HISTORIC AND DESIGN REVIEW COMMISSION

July 15, 2020

HDRC CASE NO: 2020-289
ADDRESS: 250 BENITA ST
LEGAL DESCRIPTION: NCB 3982 BLK 8 LOT 3
ZONING: R-6, H
CITY COUNCIL DIST.: 3
DISTRICT: Mission Historic District
APPLICANT: Reginald Young/YOUNG REGINALD S
OWNER: Reginald Young/YOUNG REGINALD S
TYPE OF WORK: Front yard fence
APPLICATION RECEIVED: June 28, 2020
60-DAY REVIEW: Not applicable due to City Council Emergency Orders
CASE MANAGER: Huy Pham

The applicant is requesting a Certificate of Appropriateness to install 4 -foot tall cattle panel front yard fencing including a front driveway gate.

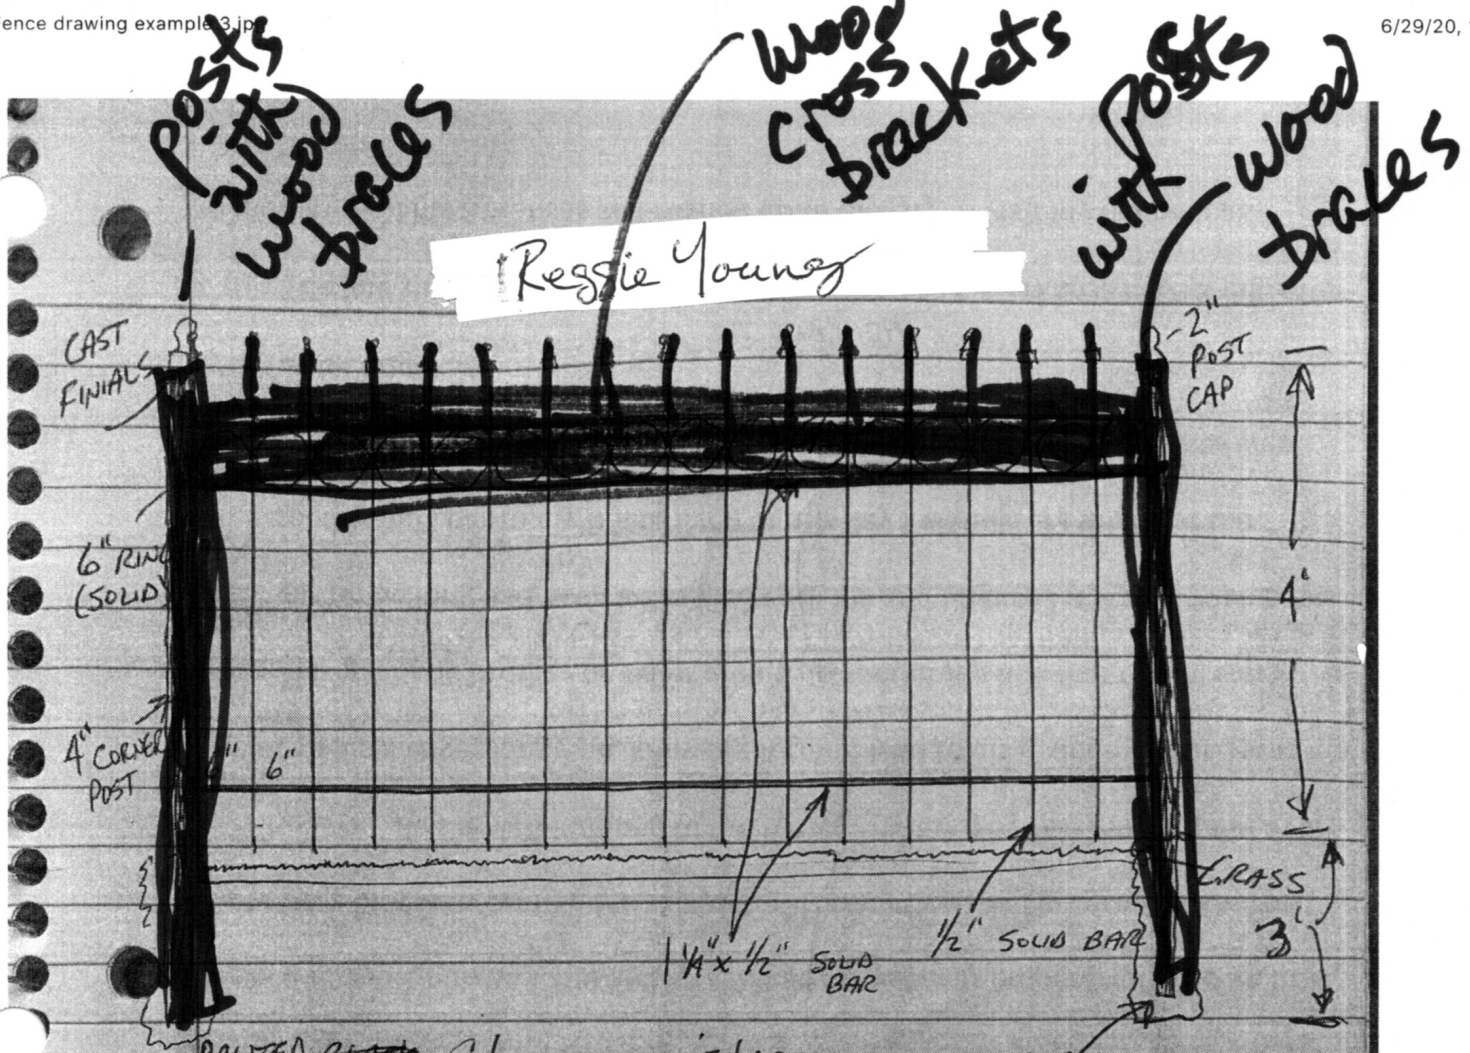
- c. FENCE LOCATION – The applicant has proposed to install the fence at the front of the property including a front driveway gate. Per the Guidelines for Site Elements 2.B.ii., applicants should avoid installing a fence or wall in a location where one did not historically exist, particularly within the front yard; the appropriateness of a front yard fence or wall is dependent on conditions within a specific historic district; new front yard fences or wall should not be introduced within historic districts that have not historically had them. Staff finds that fences are found on Benita and within the Mission Historic District at similar style structures. While front driveway gates are typically recommended against, staff finds that a turned fence into the front porch adjacent to the attached carport presents would be more inappropriate than as proposed.

- d. FENCE HEIGHT - The applicant has proposed to install a four-foot tall front yard fence. Per the Guidelines for Site Elements 2.B.iii., applicants should limit the height of new fences and walls within the front yard to a maximum of four feet. Staff finds the proposed height is consistent with the Guidelines.

Staff recommends approval based on findings b through d as proposed.
